# Aliza Fashion Ltd (Extension)

19 December 2024

## 2. Observation:

### Observation-01: Crack in the ground floor column. (Aliza Boiler Building)

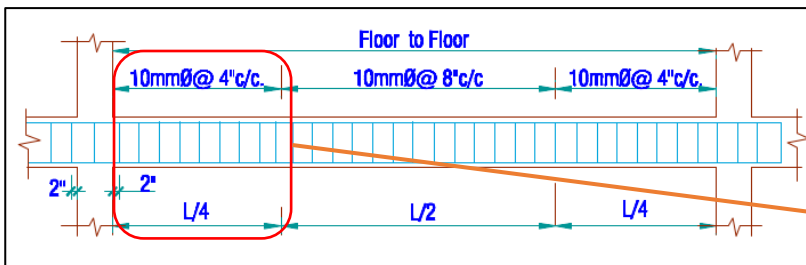
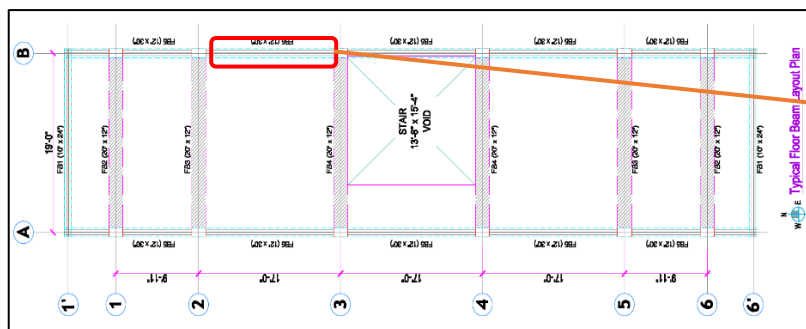
**Description:** A crack was identified on the peripheral reinforced concrete column (Grid B-6) on the ground floor. The factory must immediately engage a structural consultant to investigate the identified cracks. The building engineer is required to prepare the investigation report with a detailed repair methodology and submit it to RSC for review.

| Item No | Observation                                                                         | Action Plan                                                                                                                                             | Timeline        |
|---------|-------------------------------------------------------------------------------------|---------------------------------------------------------------------------------------------------------------------------------------------------------|-----------------|
| 1.      | Crack in the ground floor column. (Aliza Boiler Building)                           | The factory must immediately engage a structural consultant to investigate the identified cracks.                                                       | within 6 weeks  |
| 2.      |                                                                                     | Any necessary safety measures suggested by the consultant must be implemented immediately to ensure safety.                                             | within 6 weeks  |
| 3.      |                                                                                     | The investigation report, along with a detailed repair methodology, must be submitted to RSC.                                                           | within 6 weeks  |
| 4.      |                                                                                     | The required remediation work must be completed after receiving acceptance from RSC. Pictorial evidence of the work progress should be shared with RSC. | within 6 months |

**Observation-07: Lack of lateral stability and inadequate member size. (Jute & Empty Cartoon Shed)**

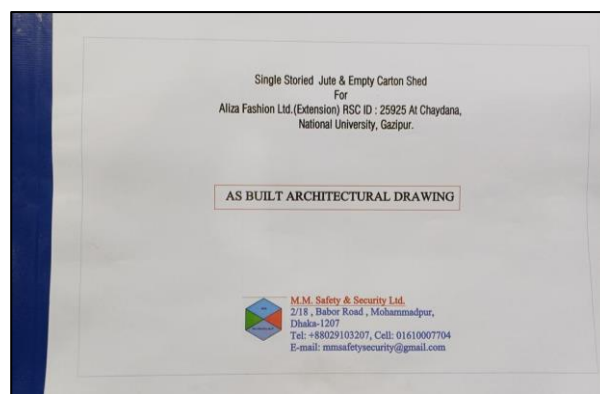
**Description:** During the inspection, load transfer media along the long direction was found missing. Also, member sizes & their connections were found to be inadequate. The building engineer is required to check the connection and member adequacy and propose remediation accordingly.

| Item No | Observation                                                                         | Action Plan                                                                                                                                             | Timeline        |
|---------|-------------------------------------------------------------------------------------|---------------------------------------------------------------------------------------------------------------------------------------------------------|-----------------|
| 10.     | Lack of lateral stability and inadequate member size. (Jute & Empty Cartoon Shed)   | The building engineer is required to check the connection and member adequacy and propose remediation accordingly.                                      | within 6 weeks  |

**Observation-10:** Corrosion on steel member. (Jute & Empty Cartoon Shed)

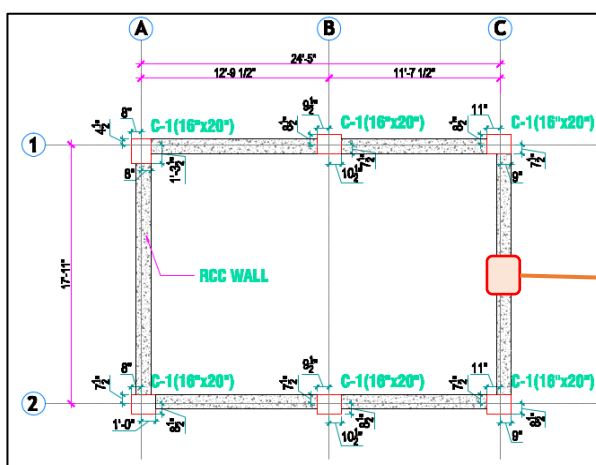
**Description:** During the inspection, corrosion was found in the steel member. The building engineer is required to remove the corrosion and provide anti corrosive coating to the steel members.

| 13. | Corrosion on steel member.<br>(Jute & Empty Cartoon Shed)                       | The building engineer is required to repair corrosion with a suitable method.                                                       | within 6 weeks |

**Observation-13:** Exposed rebar. (Fire Pump House)

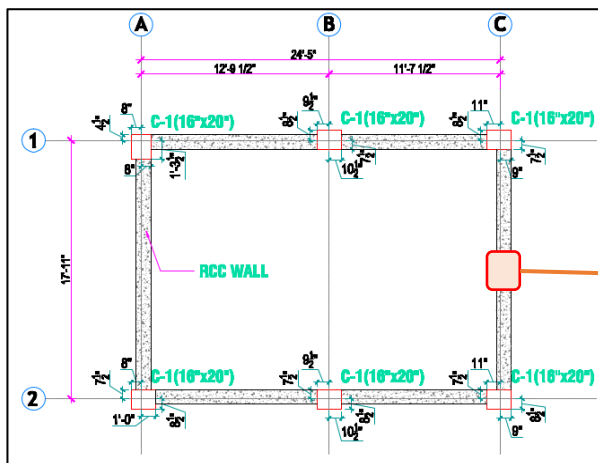
**Description:** During inspection, the exposed rebar was found on the roof slab. The building engineer is required to apply anti-rust proof coating on exposed rebar.

| 16. | Exposed rebar. (Fire Pump House)                                                | The building engineer is required to apply anti-rust proof coating on exposed rebar.                                                | within 6 weeks |
